Addendum noise and vibration impact assessment

MEMO

Project:	Valley of the Winds Wind Farm	Document No.:	Mm 005 r05		
To:	ACEN Australia Pty Ltd	Date:	25 September 2023		
Attention:	Jon Williamson	Cross Reference:	Rp 003 r01 20191254		
Delivery:	Email	Project No.:	20191254		
From:	Yuxiao Chen	No. Pages:	24	Attachments:	No
CC:	Jeremy Ellis	Belinda Sinclair	Claire Butterfield		
Subject:	Addendum to Rp 003 r01 20191254

Figure 1: Site layout – Mount Hope cluster

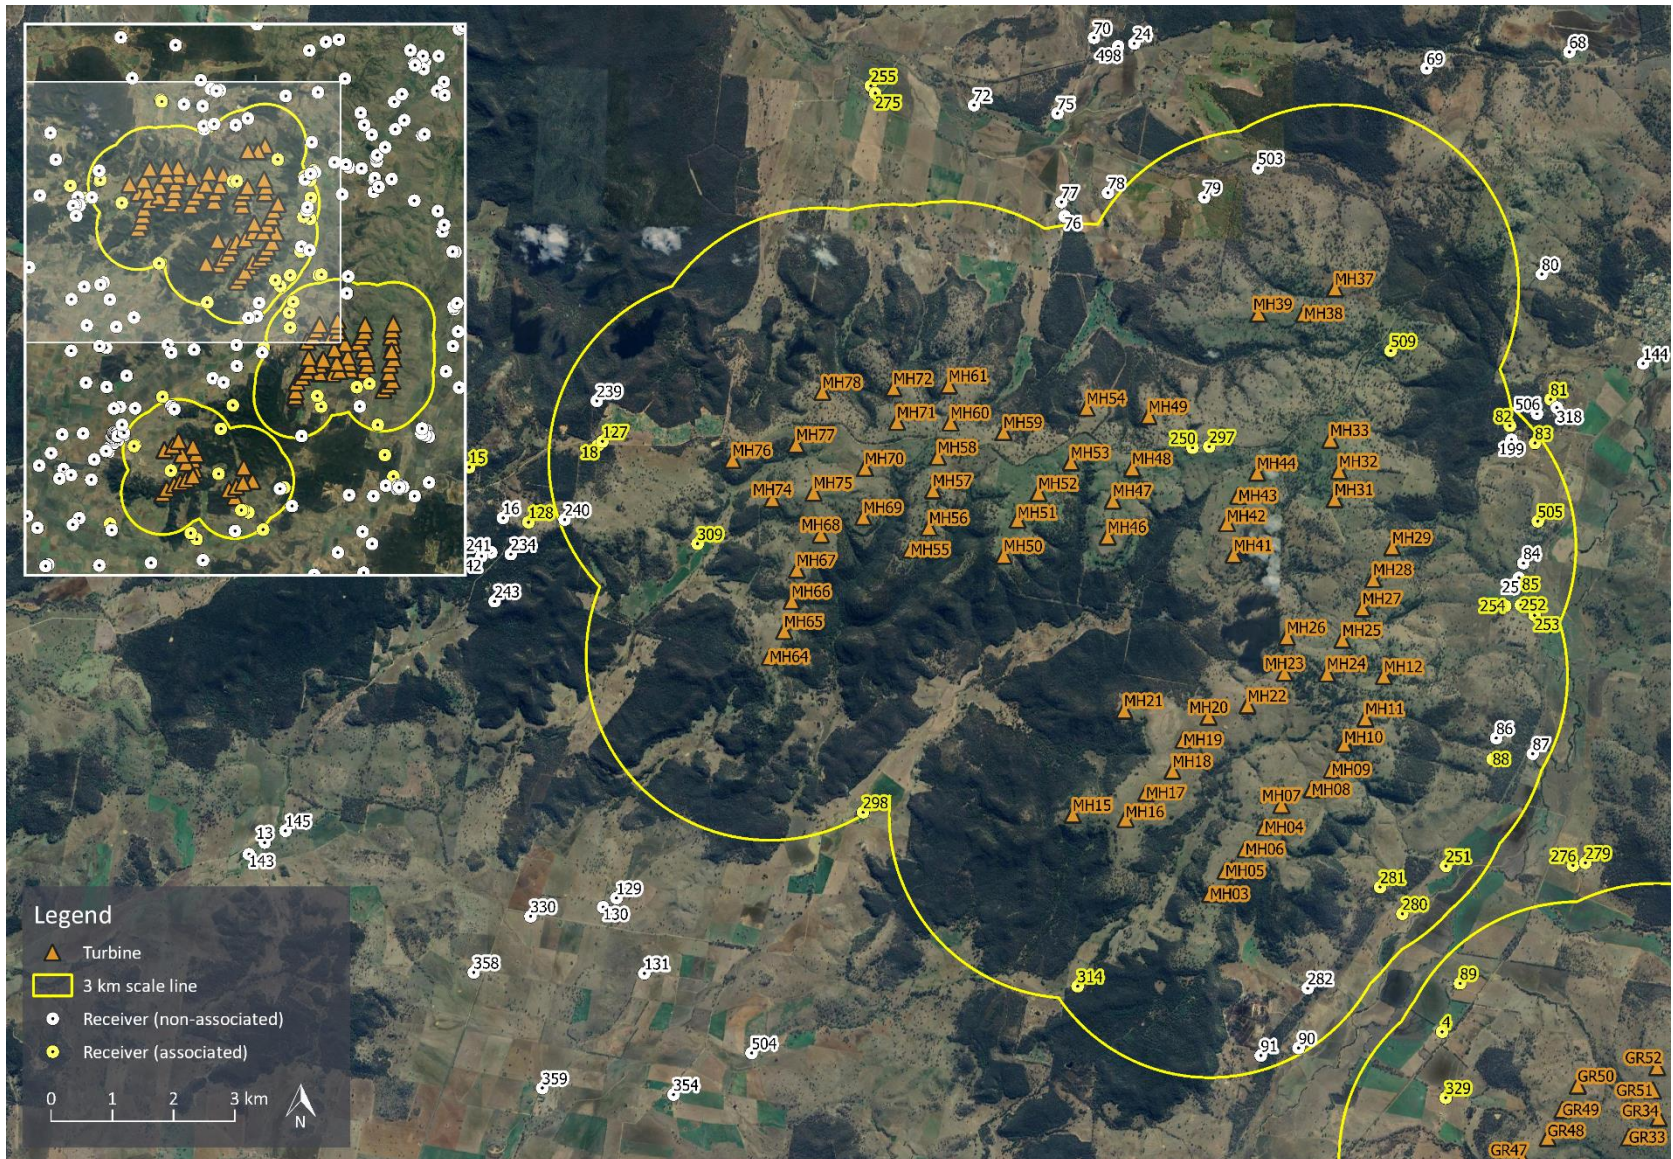
The revised wind turbine layout comprises one hundred and thirty-one (131) wind turbines, with seventeen (17) wind turbines removed, and changes made to individual wind turbine locations.

Revisions to the dwelling layout are primarily related to changes in associated/non-associated status, specifically receivers 2, 3, 18, 81, 82, 83, 88, 151, 179, 189, 298, 314, 324 and 505 changing from non-associated to associated, receiver 284 changed from associated to non-associated, receiver 502 has been added to the assessment as a non-associated receiver, and receiver 509 has been added as an associated receiver.

The revised site plans illustrating the wind turbine layout, 3 km scale line and receiver positions are provided in Figure 1 to Figure 3, for each of the clusters.

Figure 4: Highest predicted noise level contours for GE 6.0-164, dB LAeq

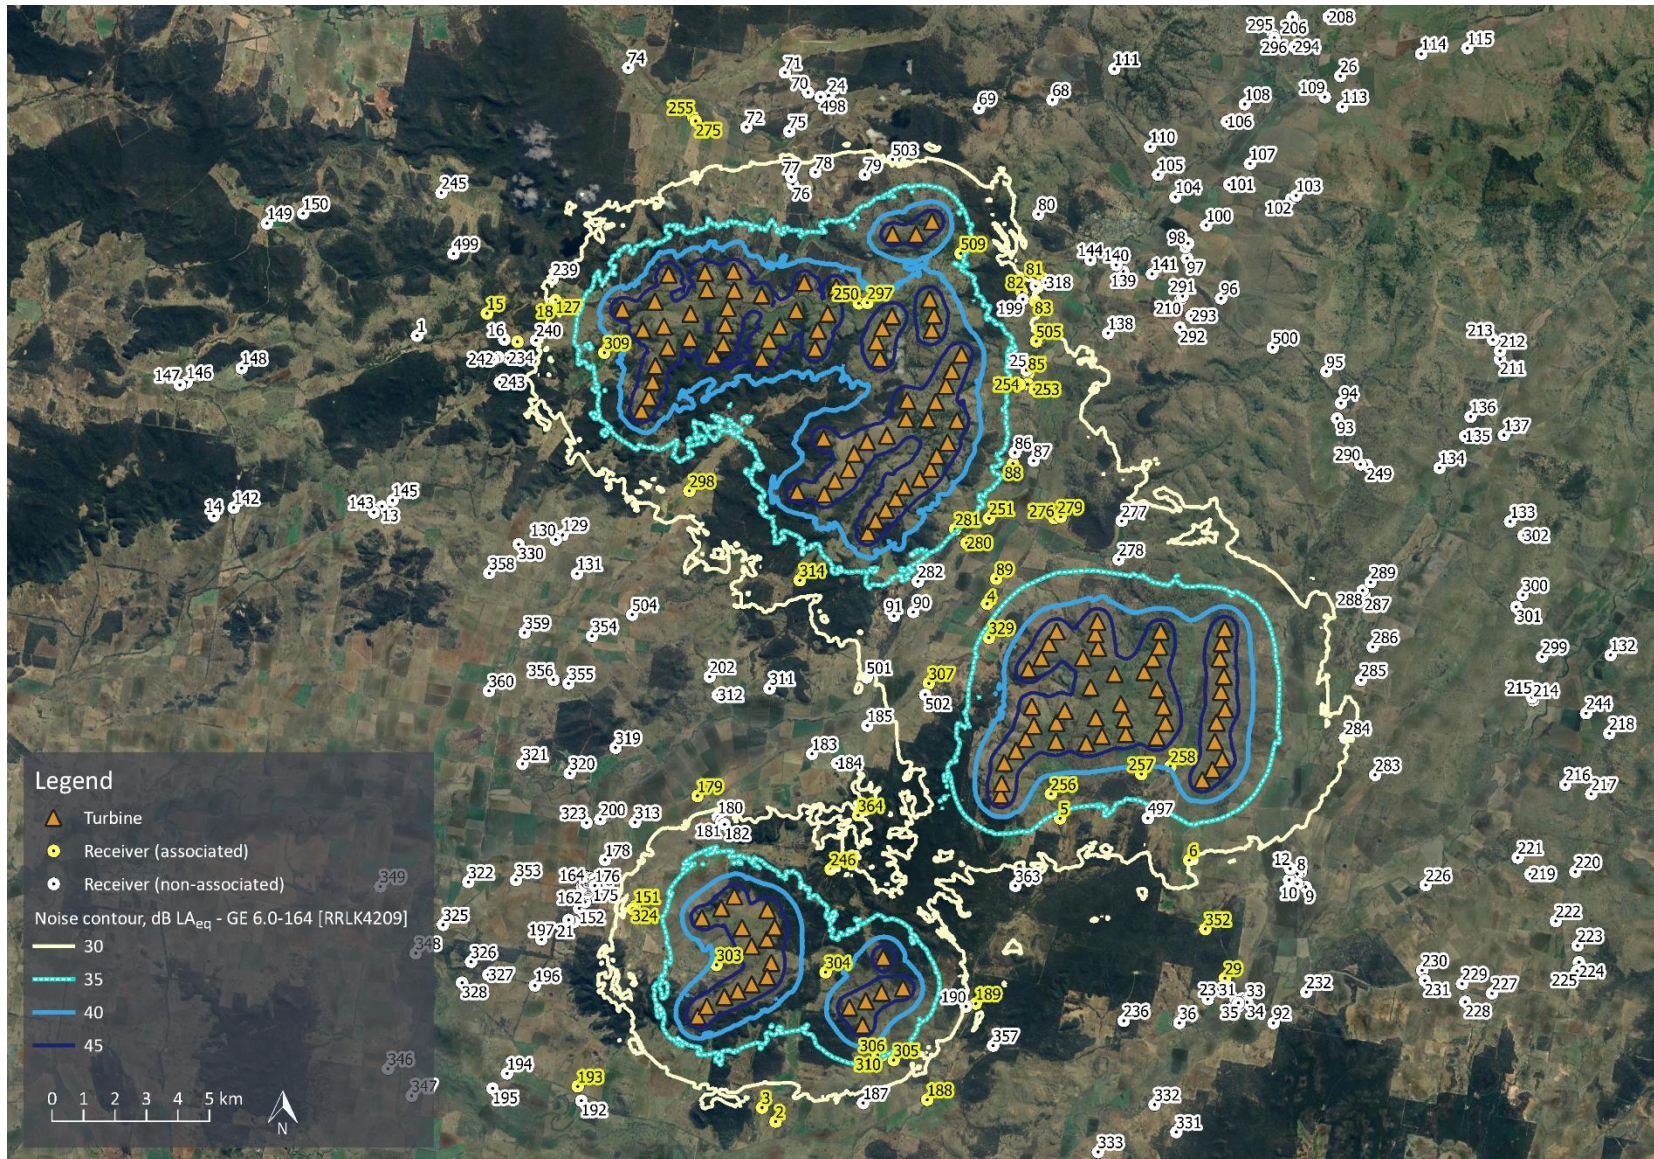
Noise modelling has been updated to incorporate the revised wind turbine and dwelling layouts. All other noise modelling parameters, including wind turbine source noise levels, topography, and ground factor inputs is the same as stated in the EIS Noise Assessment.

The location of the total predicted 30 dB, 35 dB, 40 dB, and 45 dB L_{Aeq} noise contours for the candidate turbine model with the highest predicted noise levels (GE 6.0-164) is illustrated in Figure 4.

As detailed in the EIS Noise Assessment, the minimum wind turbine noise limit applicable at non-associated receivers is 35 dB L_{Aeq} , and the reference level for associated receivers is 45 dB L_{Aeq} . The predicted wind turbine noise levels from the proposed wind farm are below the noise limit for all non-associated receivers, and below the reference level for all associated receivers.

Figure 5: Predicted 25 dB LAeq noise contour map for the Liverpool Range Wind Farm and Valley of the Winds wind farm

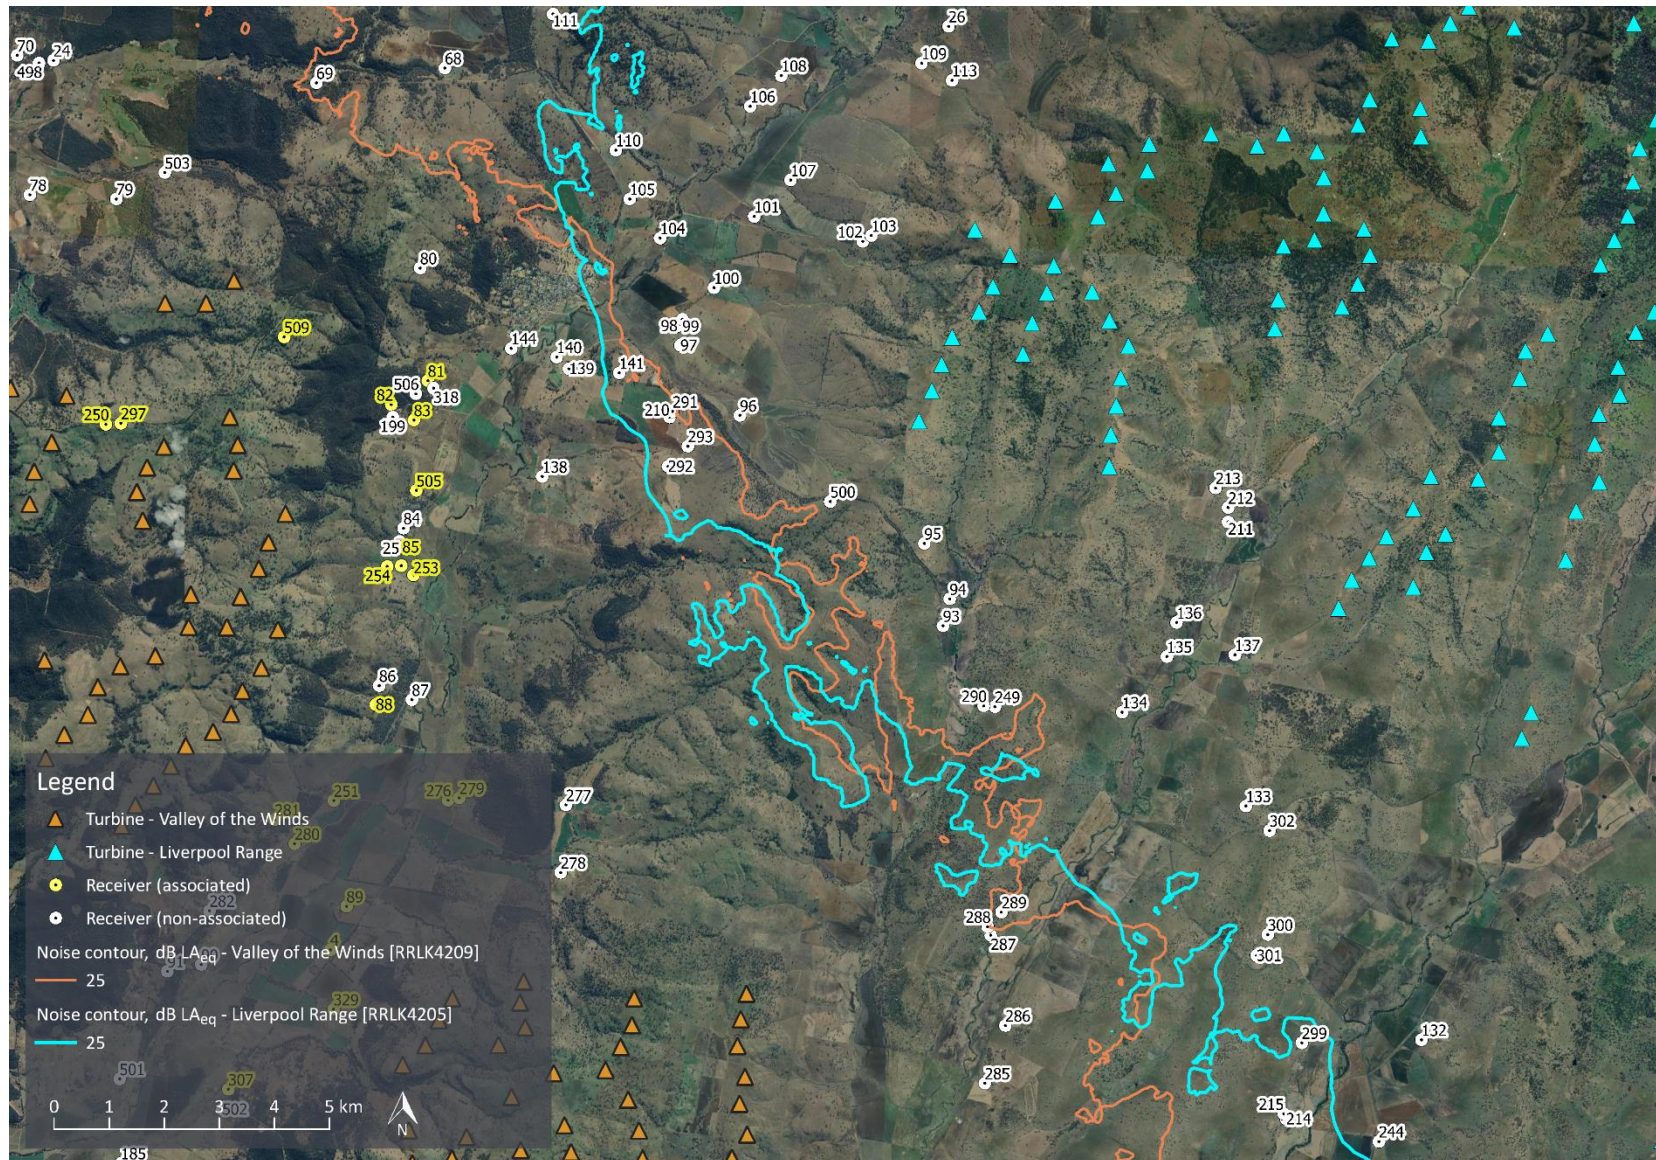
The modelling method described in the EIS Noise assessment has been reproduced, updated for the changed VoWWF wind turbine and dwelling layouts.

Figure 5 compares the predicted 25 dB L_{Aeq} contours for each project.

Predicted noise levels indicate that the compliance outcome for any relevant receiver of either wind farm does not change because of the VoWWF wind turbine and dwelling layout revisions.
